Further Information request – 35 Kaitawa Street

To	Michelle Grinlinton-Hancock
Copy	
From	Sam Thornton
Office	Wellington Civil
Date	6 November 2019
File	N-H0060.03
Subject	Further Information Request – Resource Consent Application – 35 Kaitawa Crescent (190125)

35 Kaitawa Crescent(Update): Water Storage and Hydraulic Neutrality

Further Information Response - Resource Consent Application - Kāinga Ora - 35 Kaitawa Crescent, Paraparaumu

Figure 1: Proposed subdivision

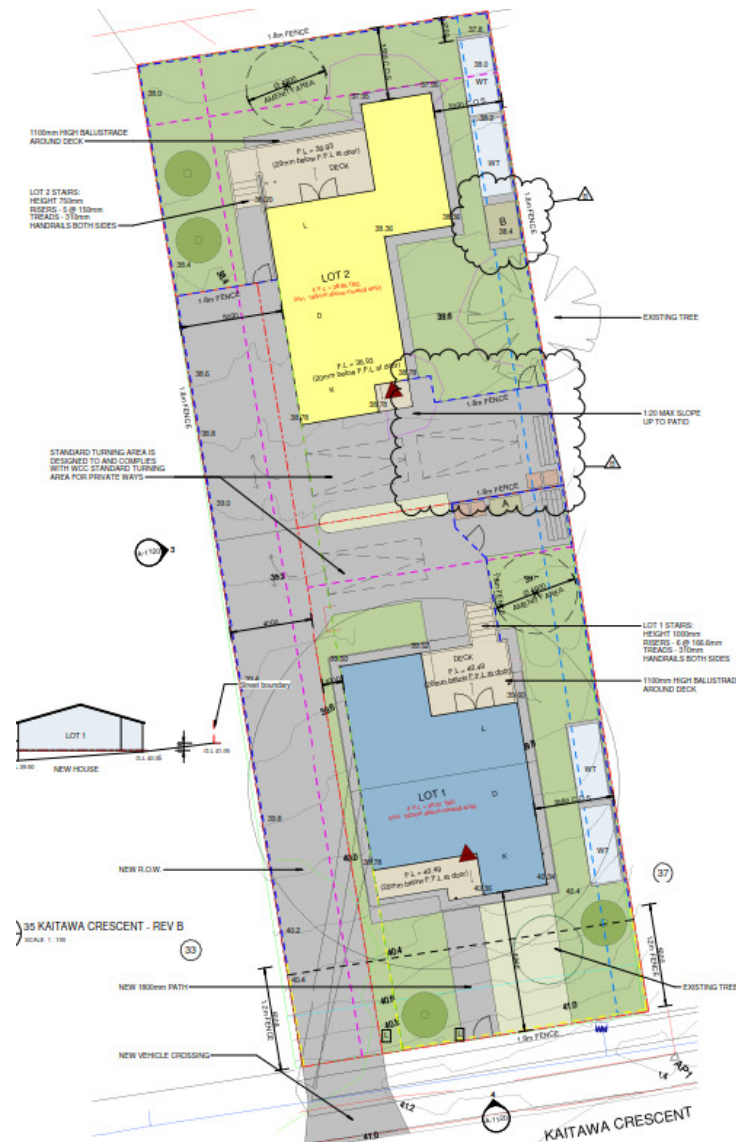
A further information request (as detailed below) has been made following the initial application for sub-division.

In addition, the decision has been made to provide two car parks in a tandem arrangement (cars parking end to end with the front car unable to exit without the back car leaving first) for the rear dwelling. Tandem parking layouts are not identified in AS/NZS 2890.1:2004 which is referenced in the Kapiti Coast District Plan¹.

Overall the proposed sub-division is consistent with the Proposed District Plan policies and objectives relating to parking despite the non-conformance in the number of parks for the front unit and the rear units parks not being designed in accordance with AS/NZS 2890.1:2004.
